June 22, 2008

**Re: Request for additional information, letter dated June 11, 2008**

PAJ, Inc. / Prime Art & Jewel

Part No. 4464-114

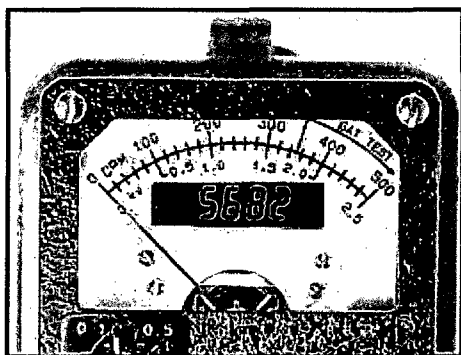
- b. *In 3.d. you state: "Although a rate meter will be used, the meter will be used to measure the integrated counts over a 5-minute counting period. Thus, the meter will not be used in rate meter mode and the response time of the meter will not affect the sensitivity of the measurement system." Please explain how you will obtain the integrated count from the rate meter.*

Ludlum produces and sells an attached scalar feature that records integrated counts for various periods of time. PAJ has obtained meters that include this scalar feature, which will be used to record integrated counts as noted earlier. Please note the image below, from the Ludlum Instruments catalog.
